GE Nuclear Energy

April 16, 1996

MFN 050-96
Docket No. 52-001

ABWR Design Change Assessment Review of FOAKE Design Changes

FIGURE 9.4-10 RADWASTE BUILDING HVAC P&ID (Sheet 1 of 3)
 ABWR DCD/Tier 2 Rev 0 21-547

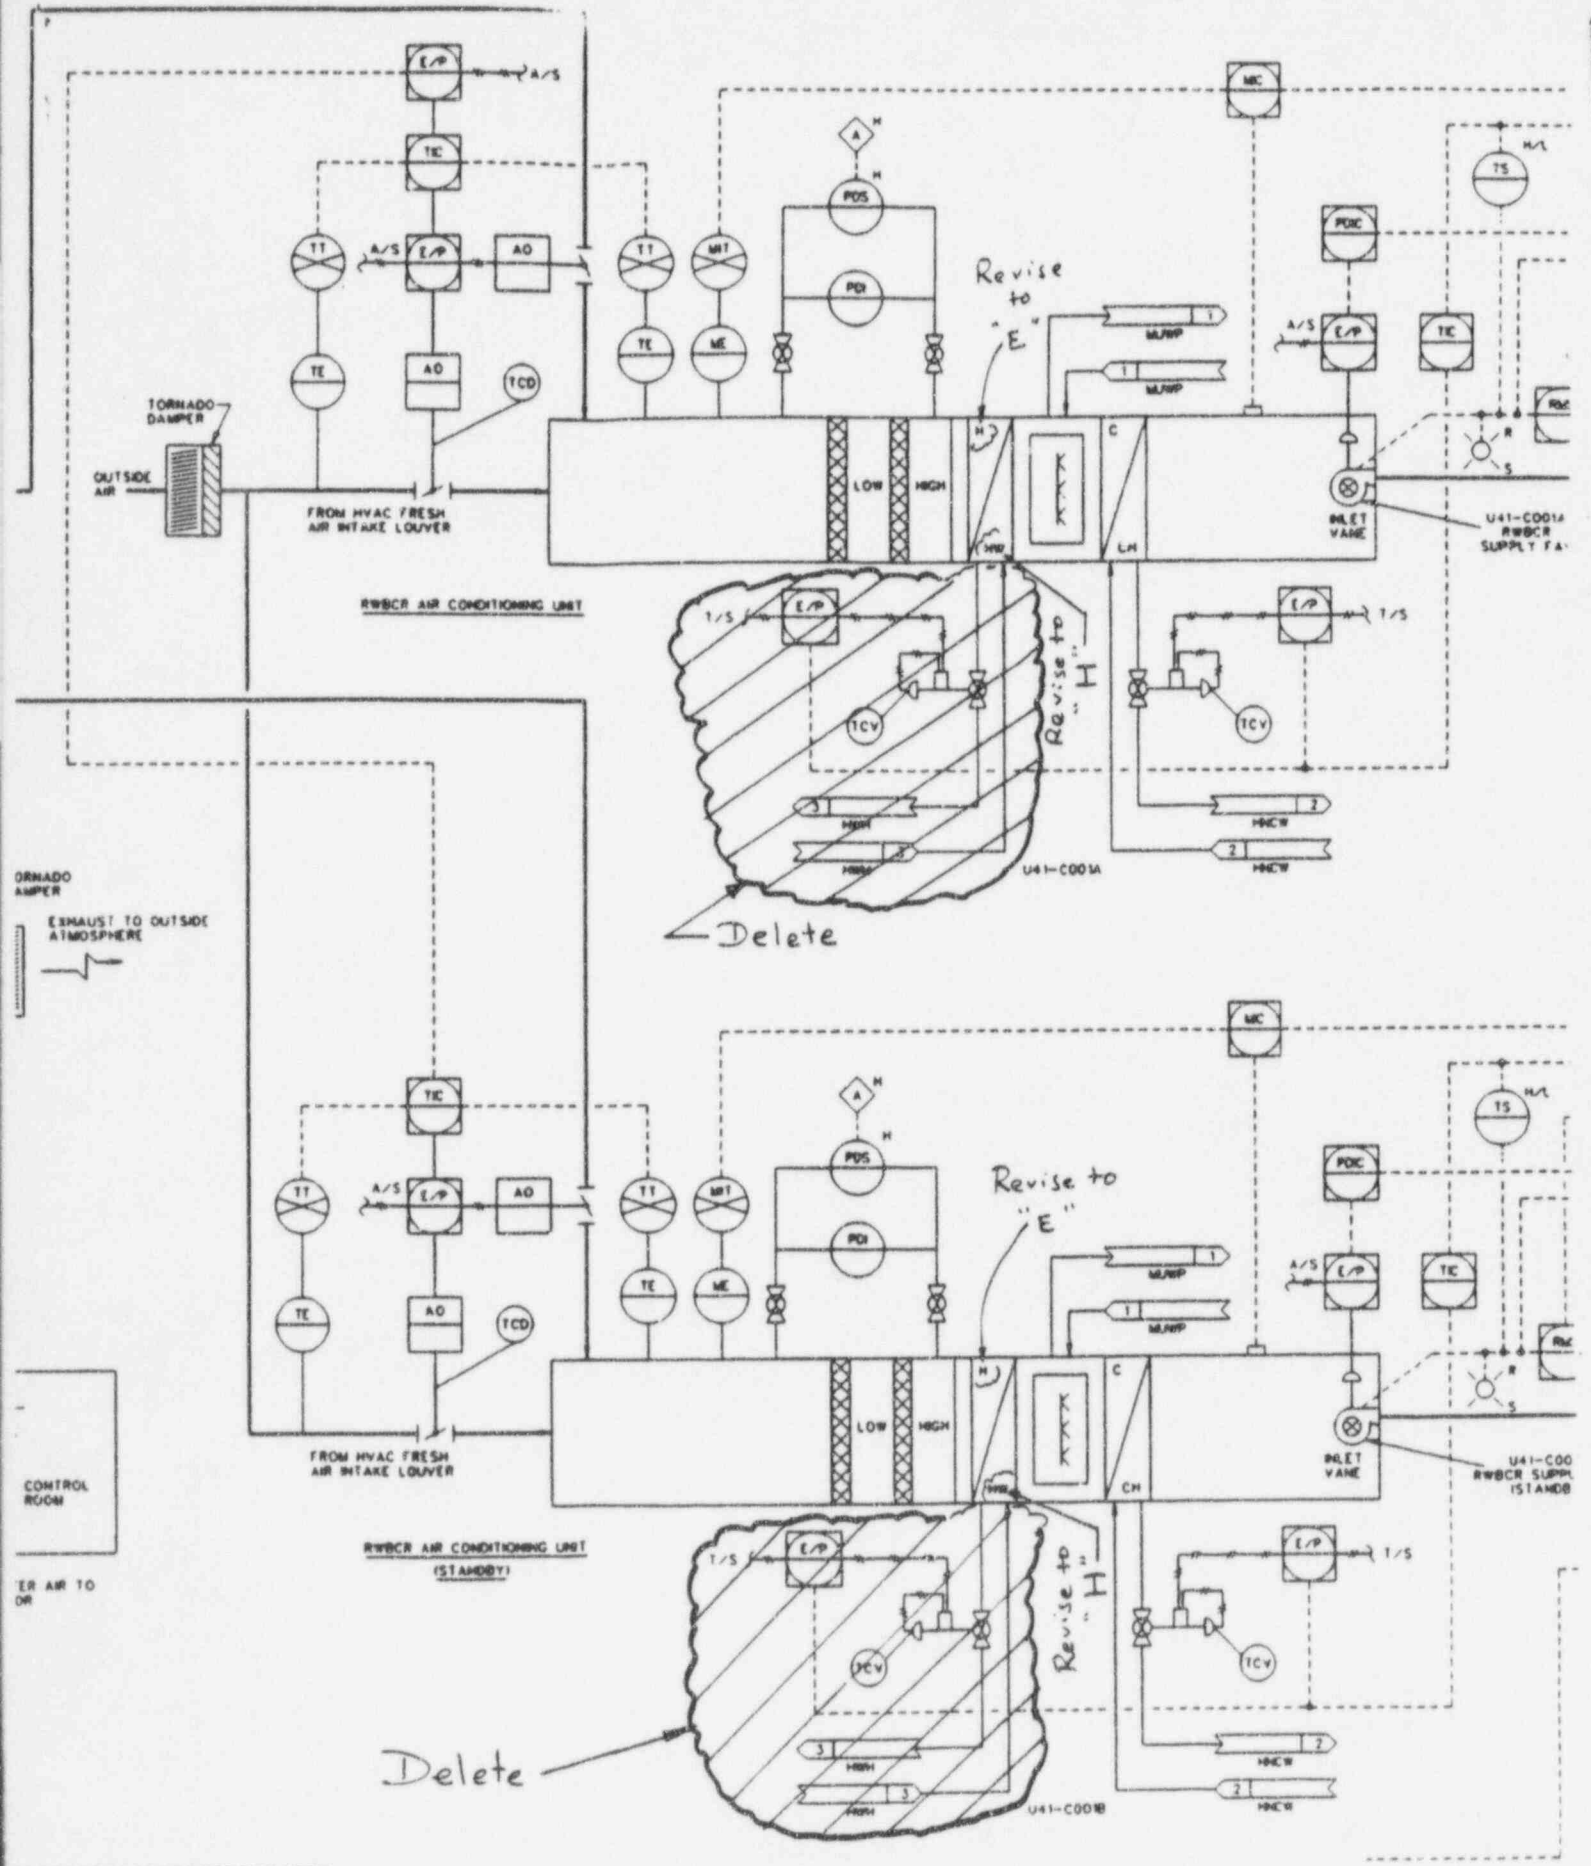
**Eliminate Hot Water Heating
for RB and RWB HVAC**

The air-conditioning unit for the radwaste control room HVAC is started manually. A temperature indicating controller modulates the air-conditioning system via ~~three-way~~ *hot water and chilled water valves* to maintain space conditions. A differential pressure indicating controller modulates inlet vanes in the supply fan air inlets to maintain the positive static room pressure. Differential pressure indicators measure the pressure drop across the filter bank. *Delete*

RCW (A)
 FIGURE 9.2-1 REACTOR BUILDING COOLING WATER SYSTEM P&ID (Sheet 2 of 9)
 ABWR DCD/TI v 2 Rev. 0 21-509

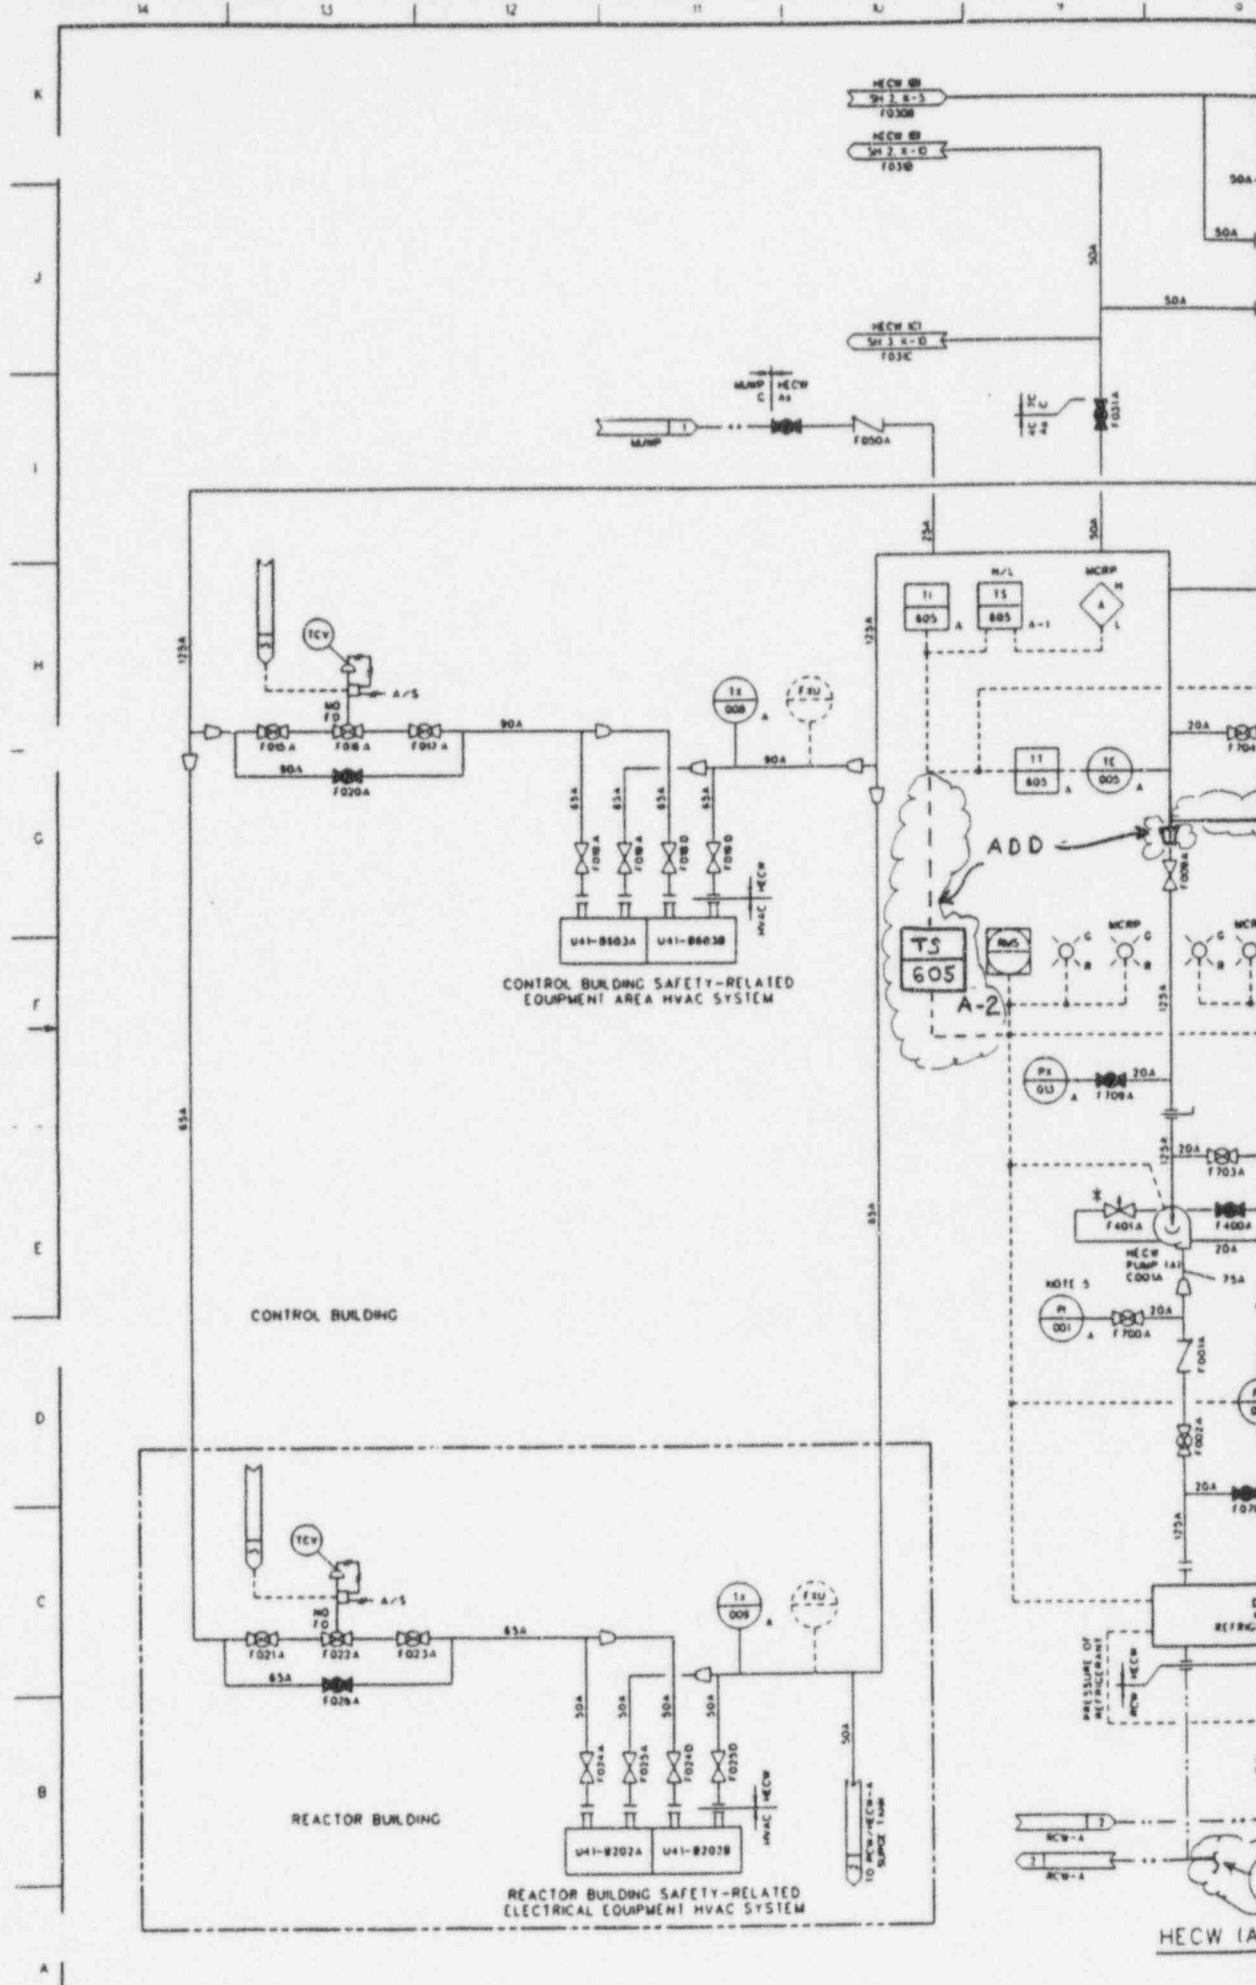
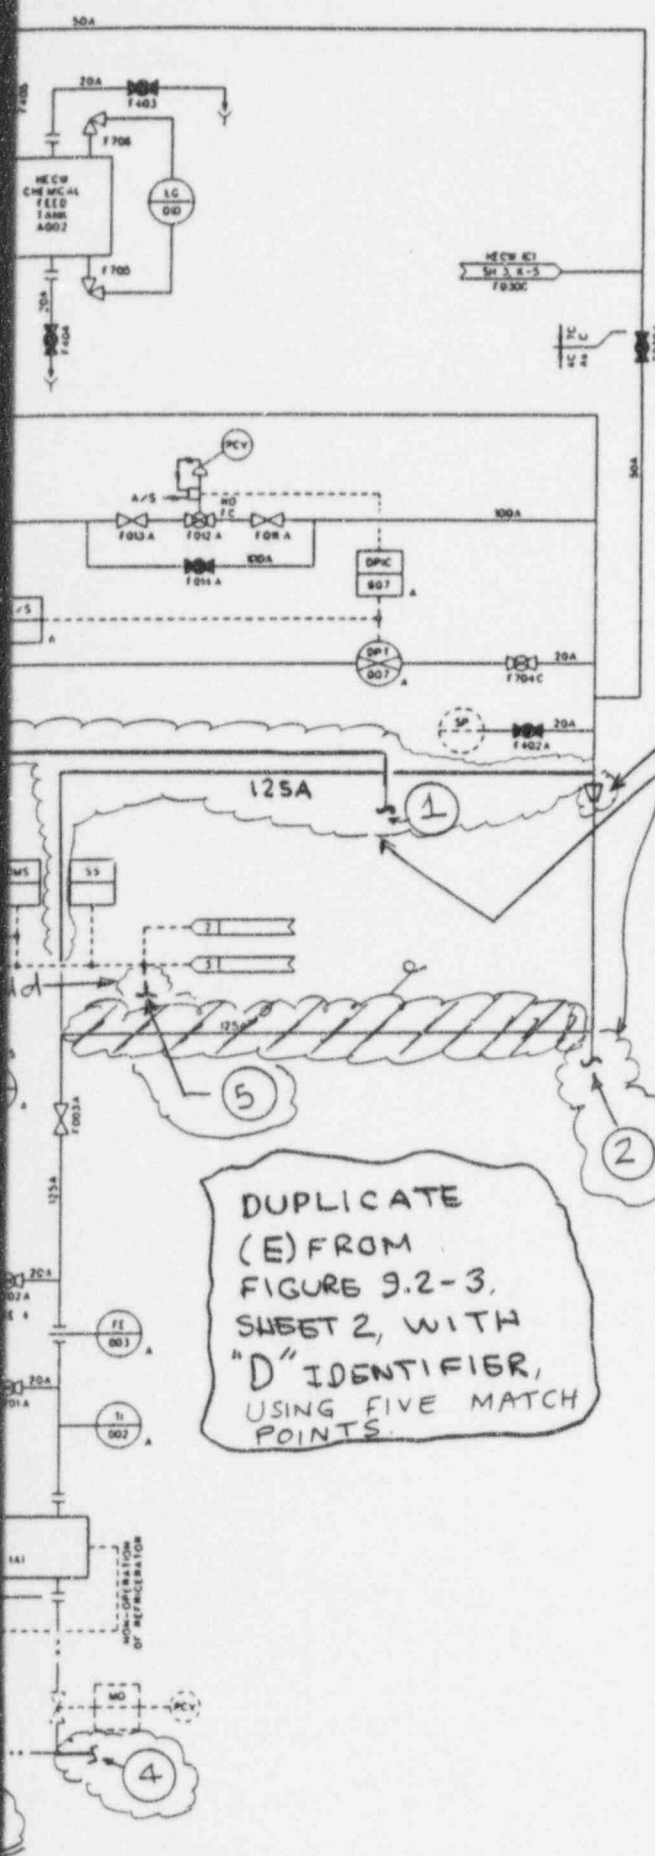
Additional Chiller/Pump Set

ADD

DUPLICATE (E) FROM FIGURE 9.2-3, SHEET 2, WITH "D" IDENTIFIER, USING FIVE MATCH POINTS.

FIGURE 9.2-3 HVAC EMERGENCY COOLING WATER SYSTEM P&ID (Sheet 2 of 3)

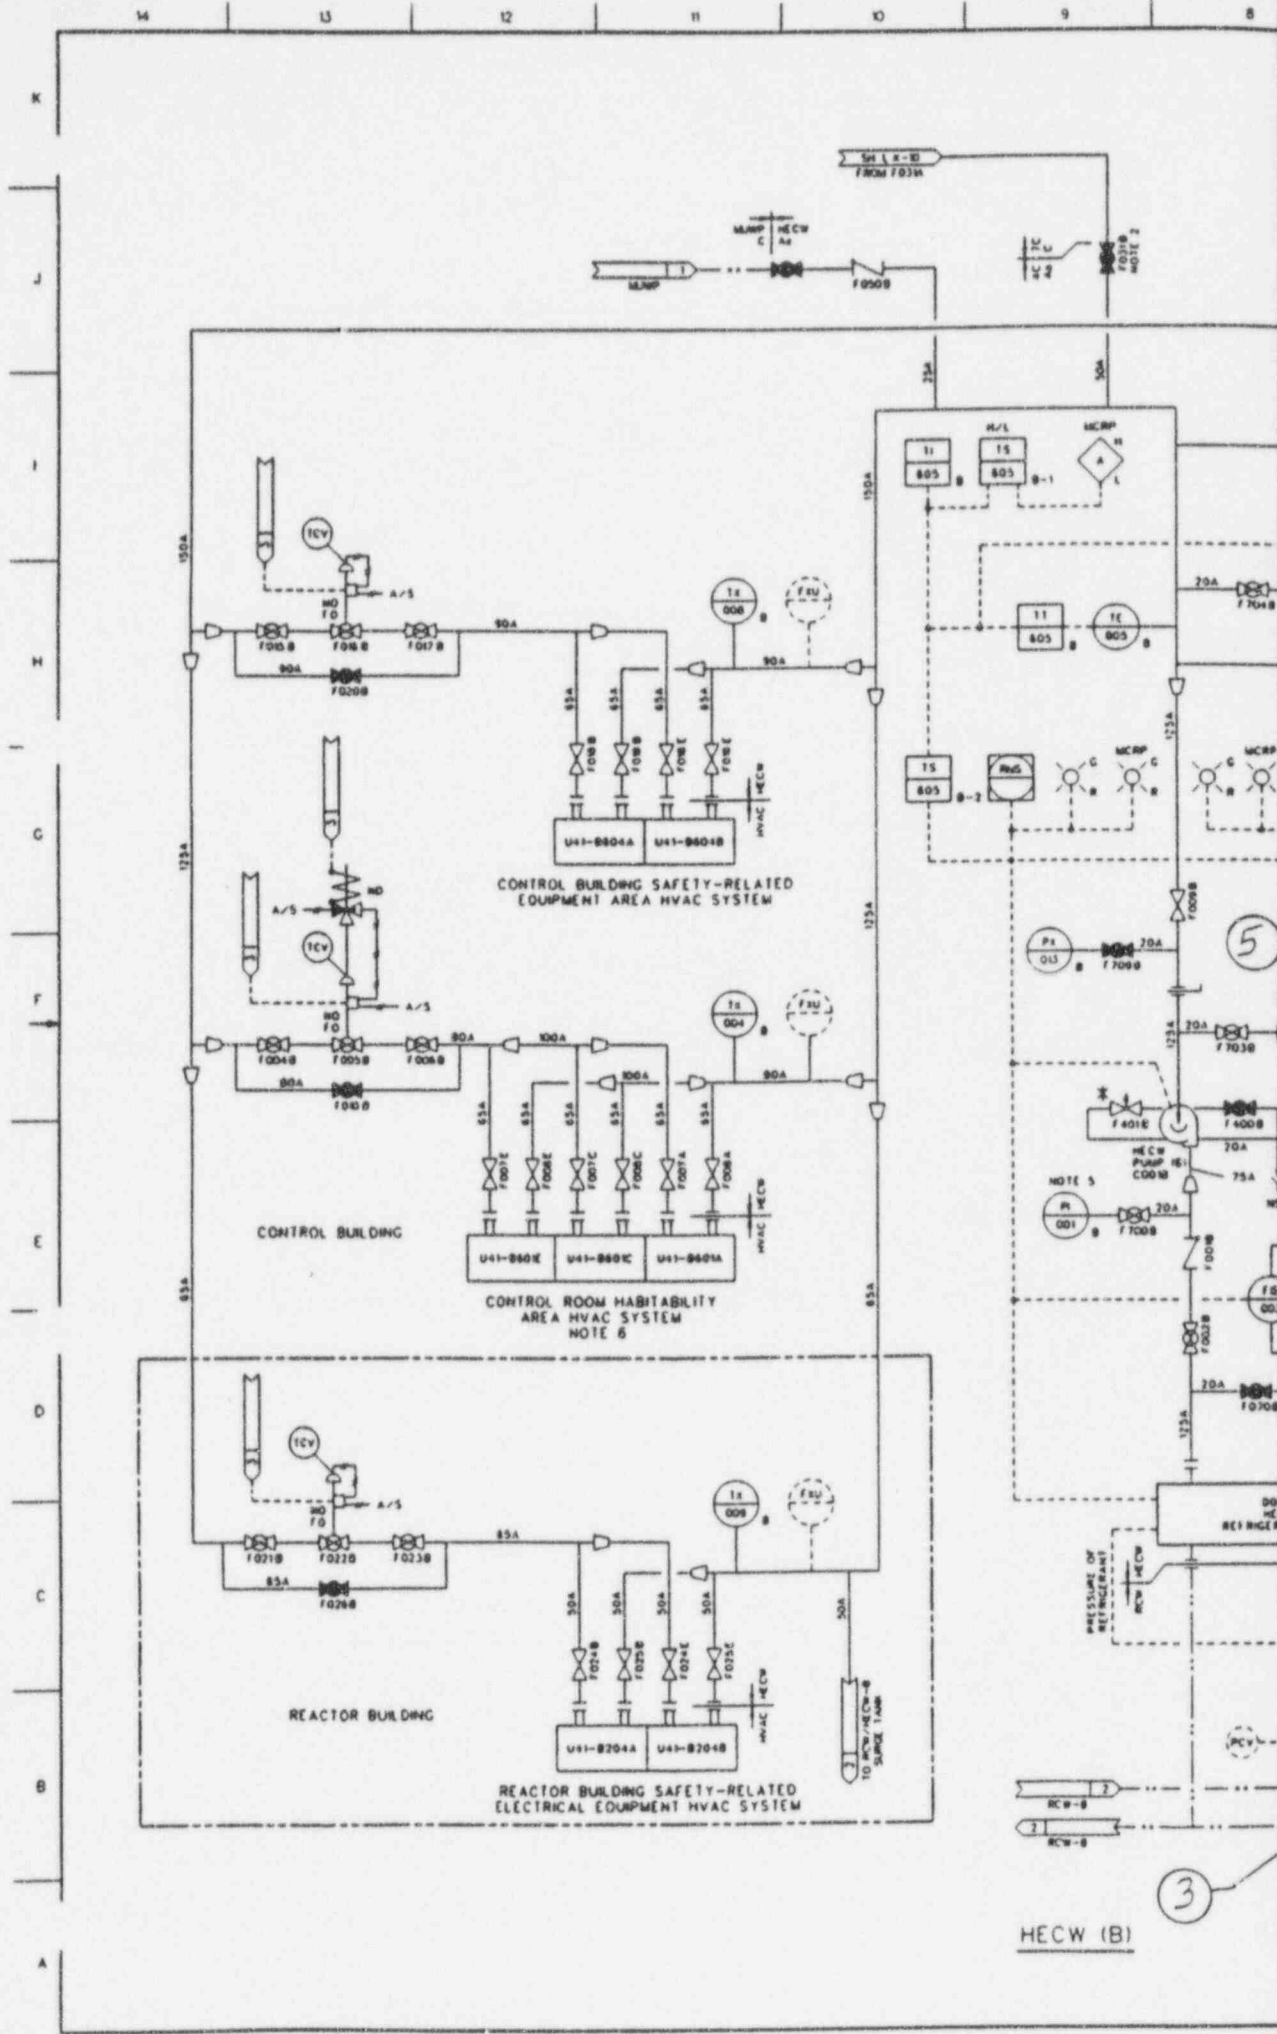
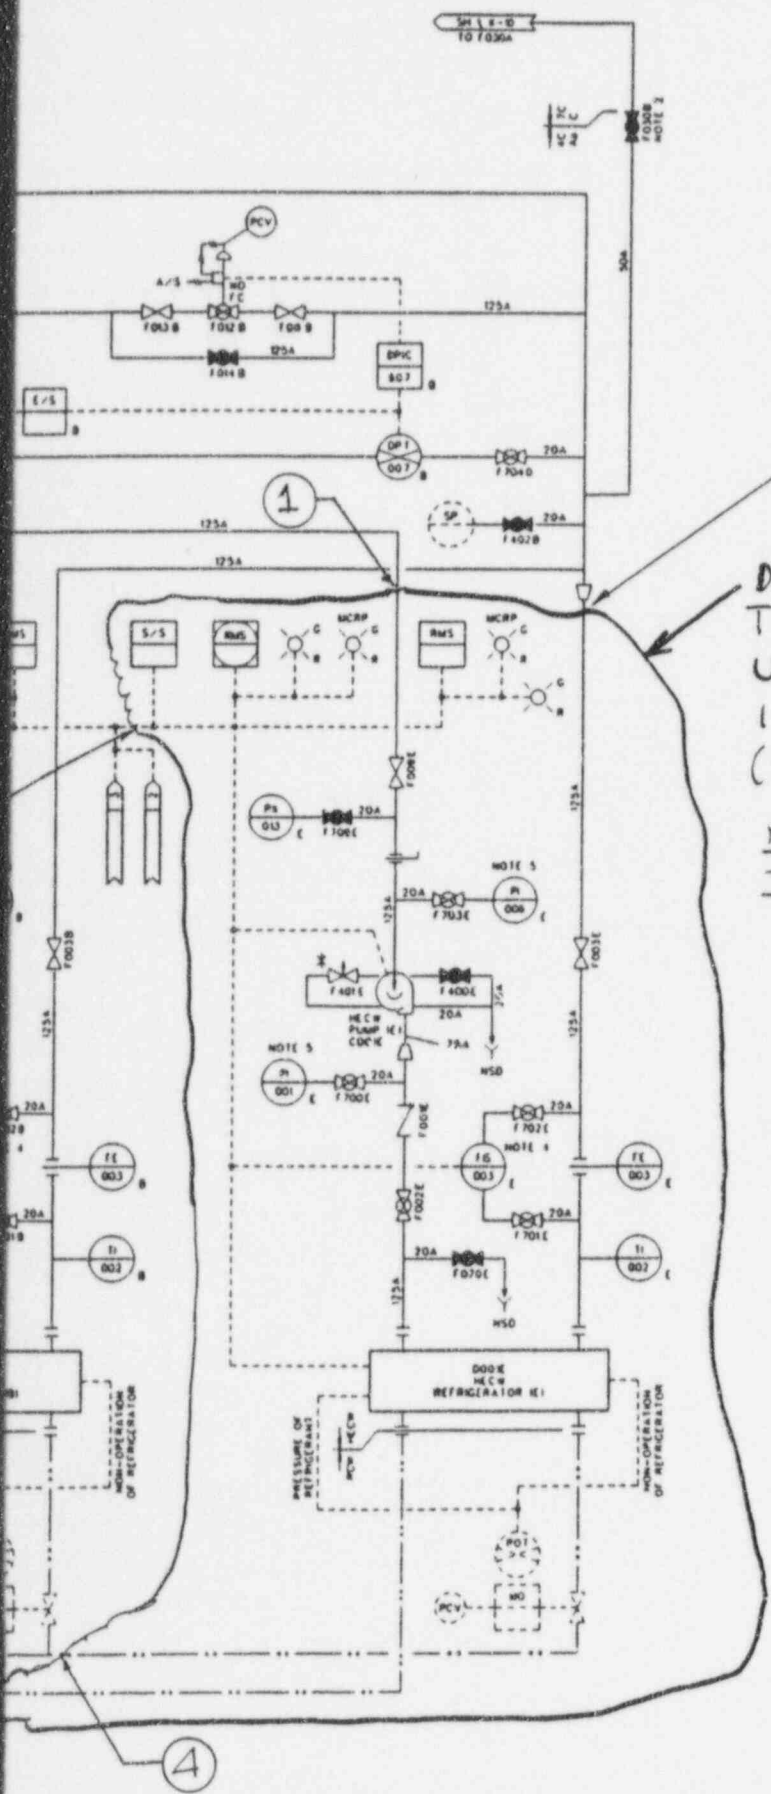
2
 DUPLICATE
 THIS REGION
 USING "D"
 IDENTIFIER
 (SEE SHEET 1).
NO CHANGE
TO THIS SHEET.
